990 BROADWAY ST NE MIXED-USE DEVELOPMENT

Re: Consolidated Land Use Application
Class 3 Design Review, Class 3 Site Plan Review, Class 2 Adjustments
990 Broadway Street NE

TO: Aaron Panko, Planner III
Community Development Department

A Class 3 Design Review and Class 3 Site Plan Review application for development of a new mixed-use development with 23 multi-family residential units and approximately 2,400 square feet of ground floor retail space. The subject property is approximately 0.35 acres in size, zoned CO (Commercial Office), within the Broadway/High Street Housing Overlay Zone, and located at 990 Broadway Street NE - 97301 (Marion County Assessors Map and Tax Lot number: 073W22AD / 08600).

SP-2

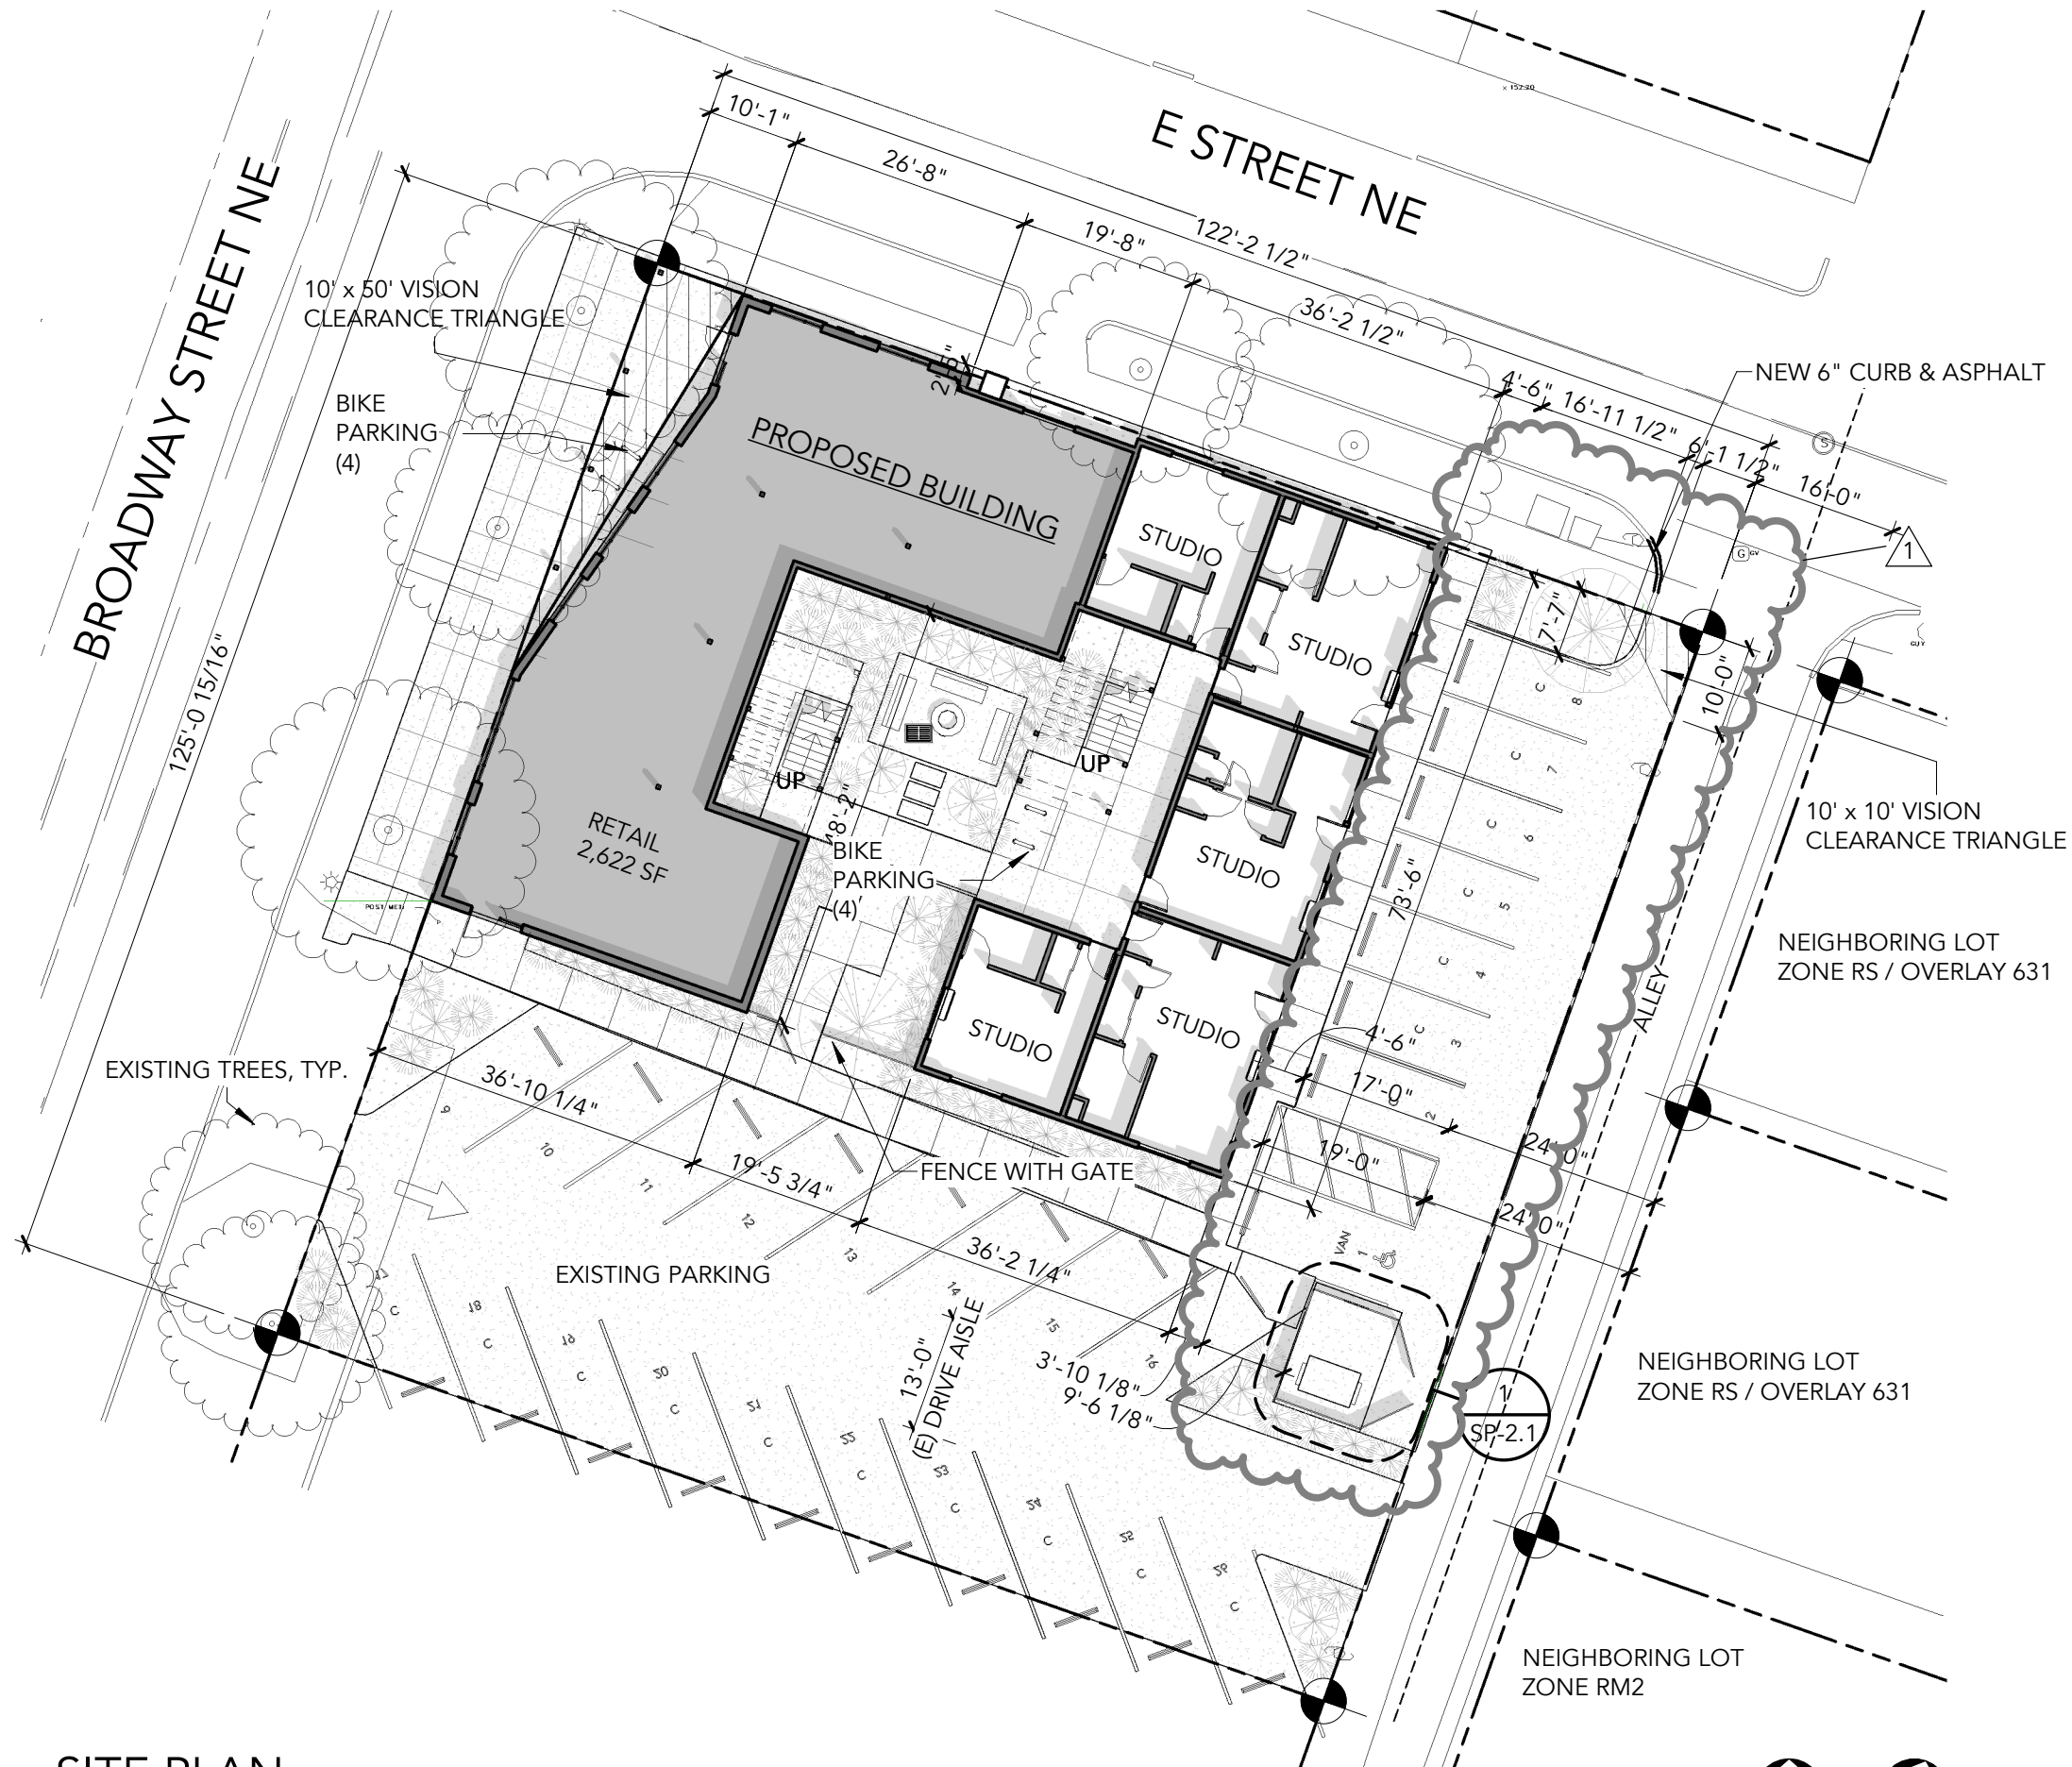
The proposed plan shows awnings encroaching into the right-of-way. The applicant shall obtain awning permits. The proposed plan also shows bicycle parking spaces within the vision clearance triangle. The bicycle parking shall comply with SRC Chapter 805.

1. Replace the existing alley approach along E Street NE pursuant to PWDS.
2. Close the existing unused driveway along E Street.
3. Obtain awning permits for proposed awnings encroaching into the right-of-way.
4. Replace non-conforming portions of existing sidewalk in conformance with the provisions of SRC Chapter 78 and PWDS.
5. Protect existing street trees during construction in conformance with the provisions of SRC Chapter 86 and PWDS.
6. Proposed bicycle parking within the vision clearance triangle shall comply with SRC Chapter 805.
